HISTORIC DISTRICT REVIEW BOARD MEETING AGENDA

- a. **APPLICATION FOR AN ALTERATION, HDRB #23-016**, to consider an application for a Certificate of Appropriateness for the construction of a new accessory structure in the rear yard of the single-family house located at 637 Oak Street, Herndon, Virginia, on the southwest corner of the intersection of Oak Street and Florence Place, and further identified as Fairfax County Tax Map 0162 02 0100C. The property is zoned R-10, Residential Single-Family District and consists of approximately 10,453 square feet of land. Owners: Melanie Adelle Tatum and Jordan Timothy Tatum. Applicant: Sean Ruppert, Opal Design Build.

Title: HDRB #23-016; New Construction; 637 Oak Street

PERSPECTIVES

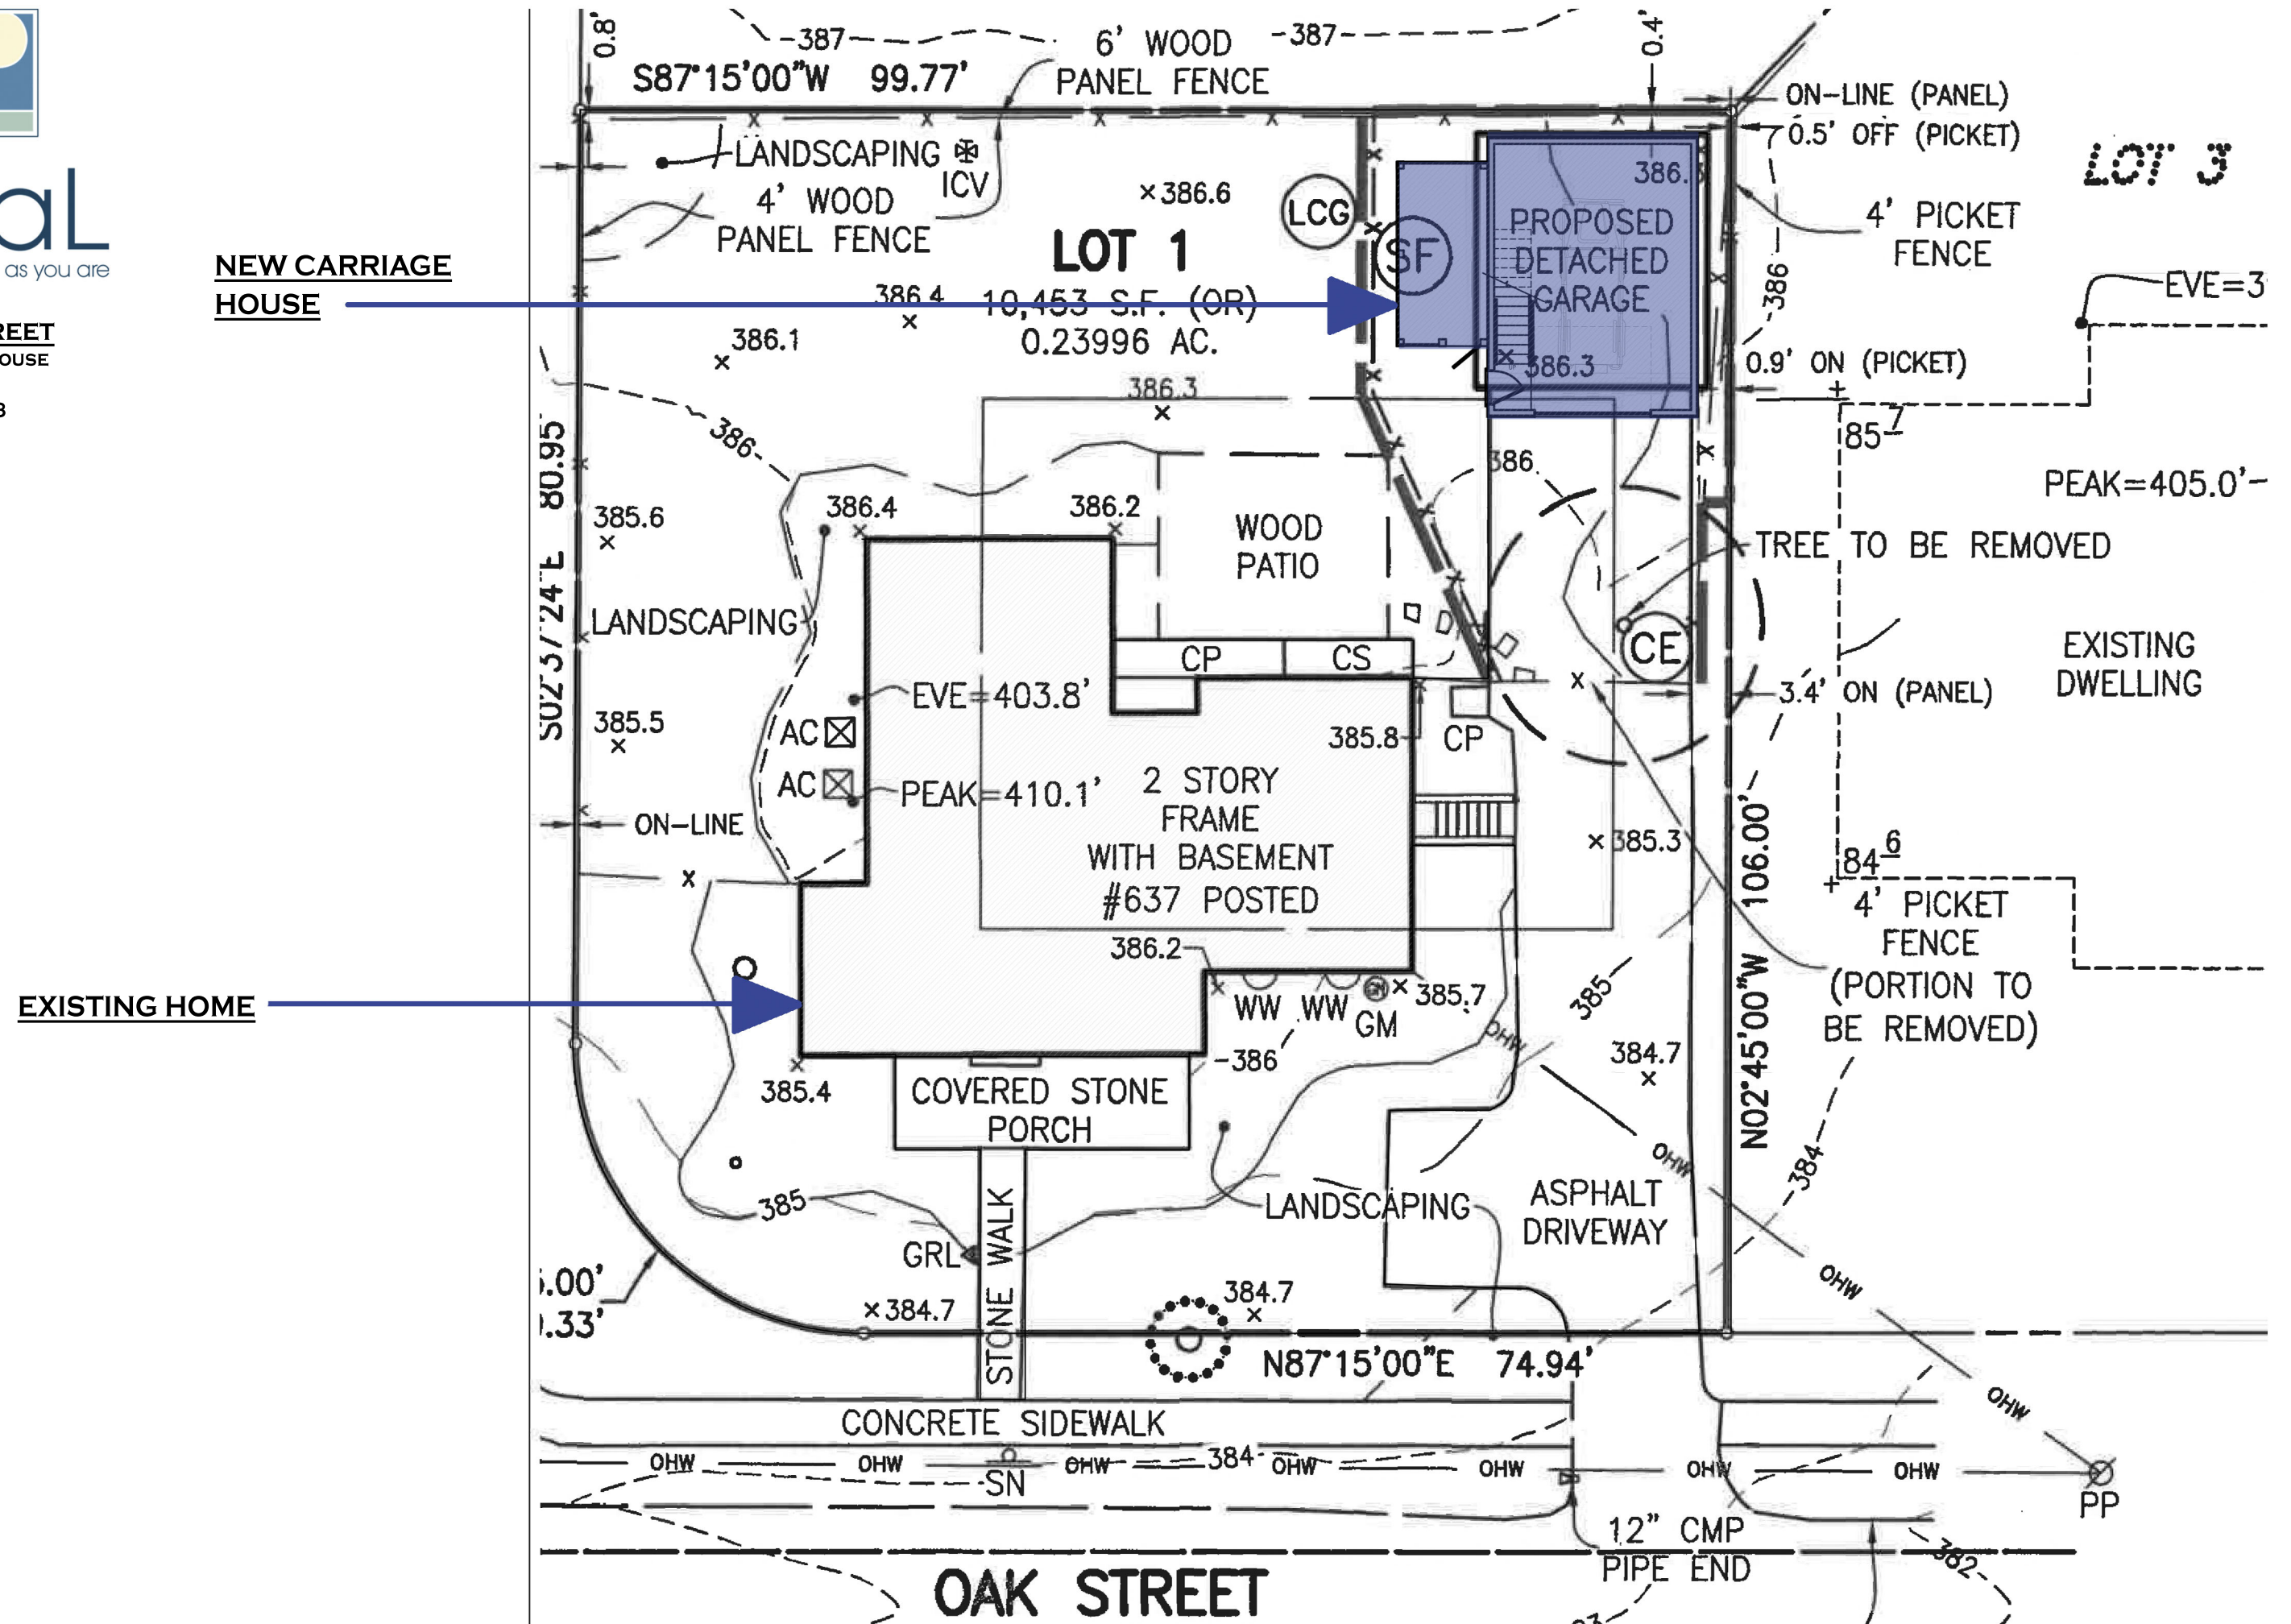
The renderings show a front-loading garage door, four windows in the front shed roof dormer, exterior light fixtures, and identify the primary cladding materials as Hardie Lap Siding and Trim painted Sherwin Williams Snowbird. The structure is located at the far southwest corner of the lot and would be accessed by an extension of the existing driveway to the right of the primary structure.

5. **General Design.** The proposed design is traditional in general shape and style – form, side gabled structure, lap siding, gable windows -- with some modern components – wide shed roof dormer with square windows, wider reveal lap siding.

Both structures also make use of dormers – however, while the proposed garage uses horizontal Craftsman style shed roof dormer with multiple windows, the main structure features distinctive engaged dormers with gables and vertical windows. The Board may wish to discuss the appropriateness of this crossover of architectural styles. As mentioned below, changing the roofing material to standing seam or a metal shingle-like product may also increase the structures compatibility with the main structure. Elevation drawings of all sides and detailed materials information will be helpful in a more complete review for design appropriateness.

6. **Windows, roof and other exterior materials.** Staff is requesting detailed materials specifications for all exterior components including window and roof materials. Windows and roofs in particular should take queues from the existing structure. The Board may want to discuss the potential use of a metal roof – standing seam or mock shingle – instead of asphalt shingle, to help the new garage integrate more completely with the contributing structure. All exterior components should adhere to the HDO Guidelines for new construction and alternative materials (see Attachment #1 Guidelines Matrix). This includes the exclusion of vinyl or plastic components, windows featuring interior muntins instead of fully simulated divided lites, and other guidance.

Staff is requesting the following additional information or alterations prior to making a recommendation to the Board:

- Measured, to-scale elevation drawings of all four sides of the proposed structure.
- Complete manufacturer specifications for all exterior materials and components.
- A document or mass study illustrating the proposed structure in relation to and in the context of the existing contributing structure.

SITE PLAN

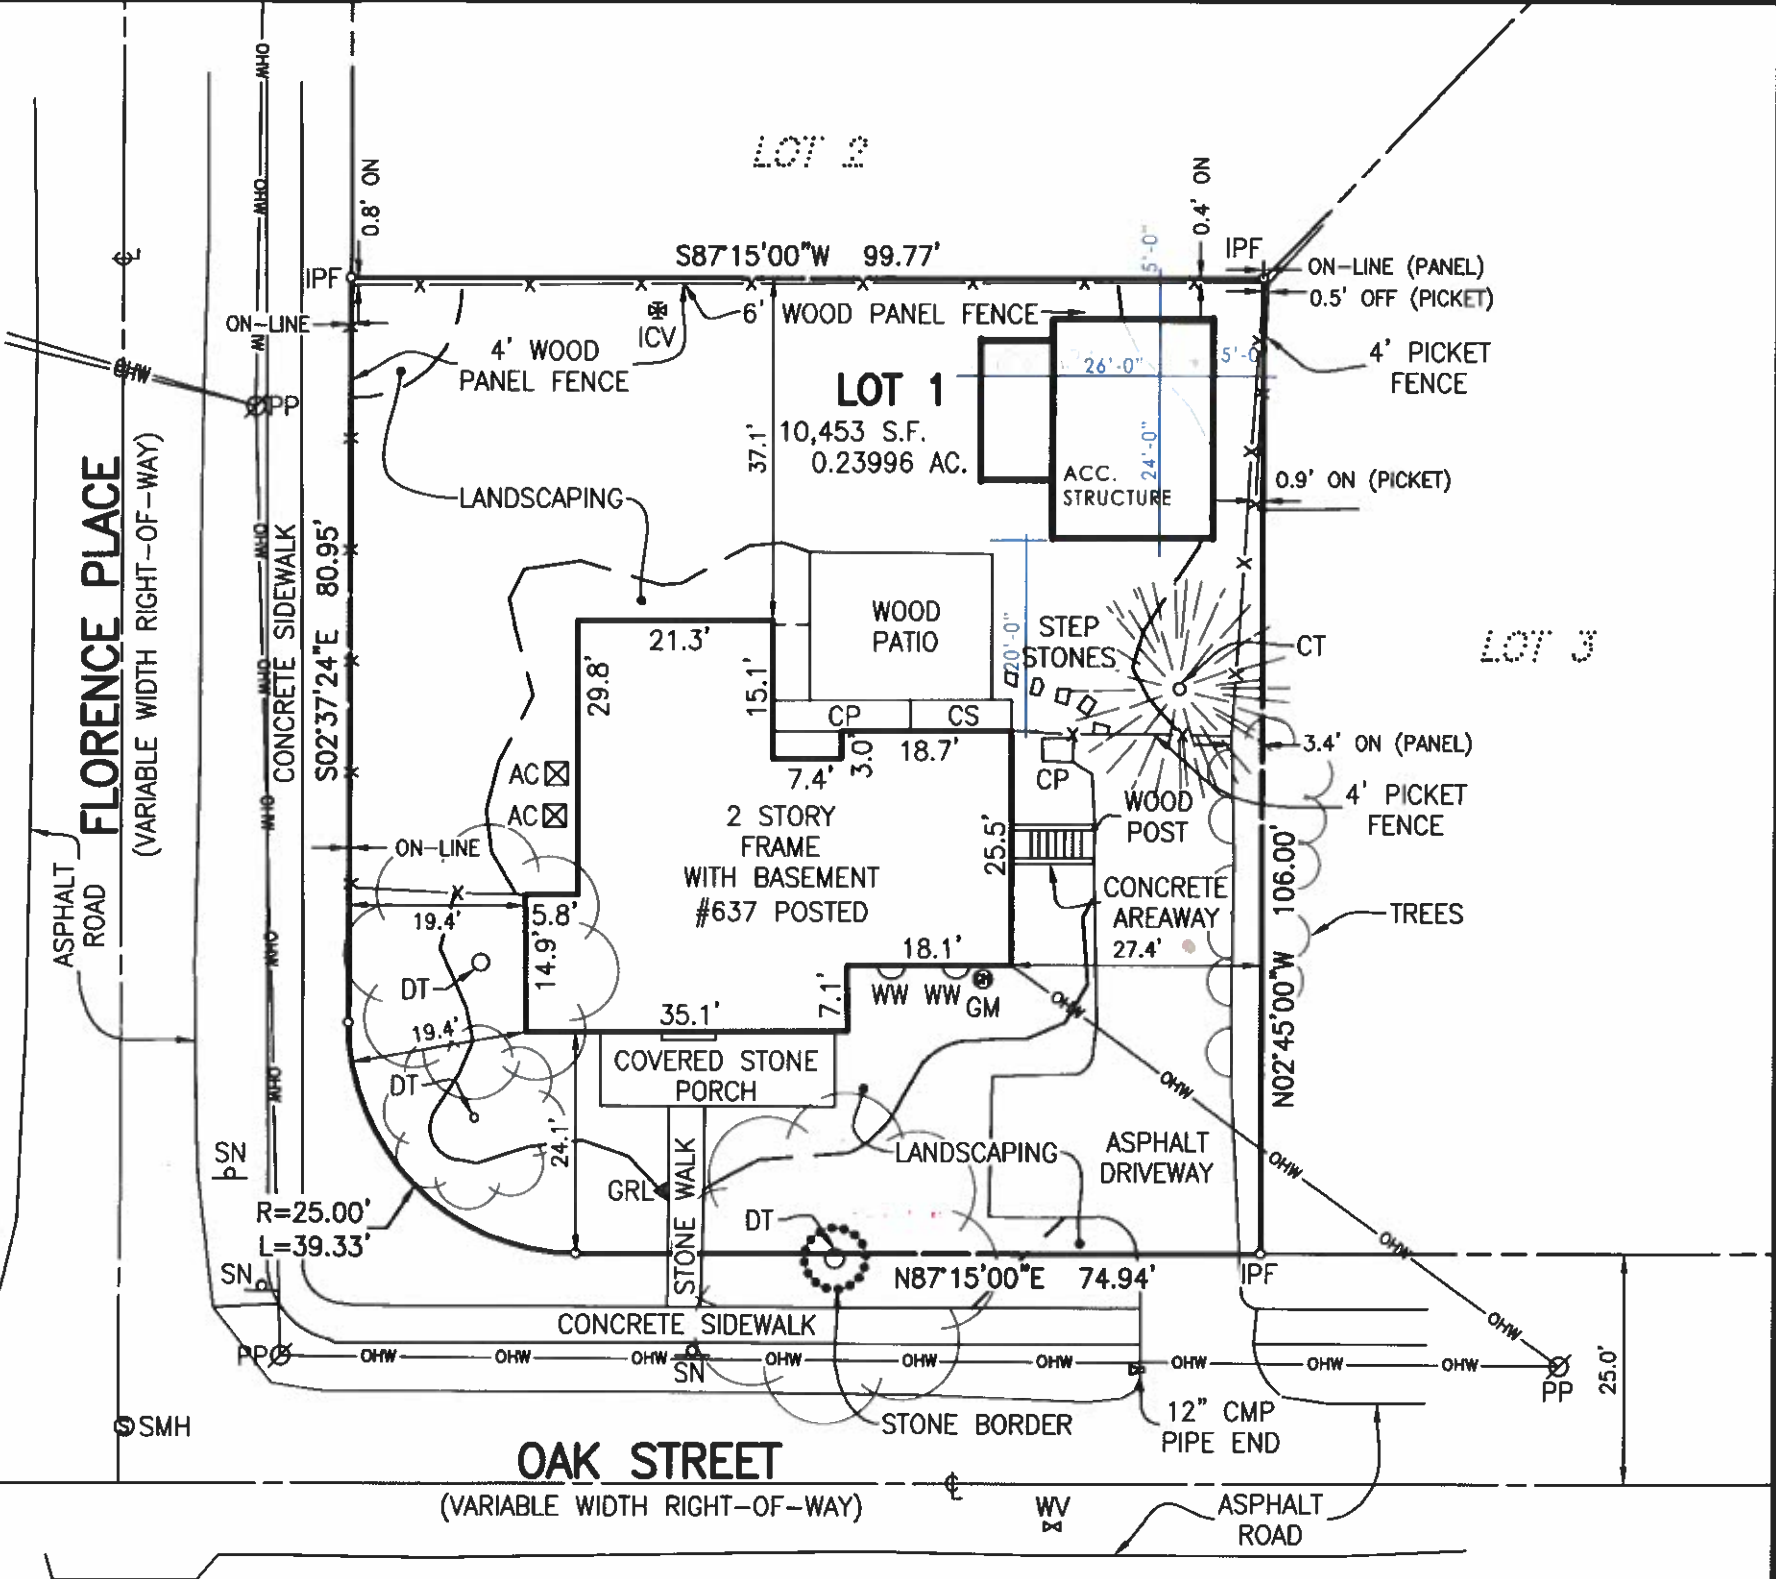
4. **Size, Massing and Location.** The Guidelines state that special care should be taken when constructing accessory structures associated with a contributing structure to “ensure that they do not detract from the character of the district.” A large part of reviewing for compatibility with the district is looking at the size, location and massing of the structure. The proposed structure is situated in the far southwest corner of the lot, appropriately recessed from the Oak Street frontage and the Florence Place frontage and is accessed by an extension to the existing driveway.

The size and massing appear to be reasonable for this area, but we need to understand 1) exact dimensions including height, of the structure (this would be provided when the applicant submit measured elevation drawings) and 2) how the size, height and mass relate to the existing contributing structure. The first point, exact dimensions, should be included with the measured elevation drawings mentioned above. The second point can be addressed in a number of different ways according to the preference of the applicant. For larger projects or additions, we would request a rendering of the proposed along with the existing structure in order to understand their relationship and the view from the street. Staff does not believe that this project merits requiring a measured drawing of the existing and proposed structures together. The scale of the proposed structure in relation to the existing structure could be described in a simpler, general way with a massing study, or perhaps a photoshop exercise showing the view from the right of way and both structures.
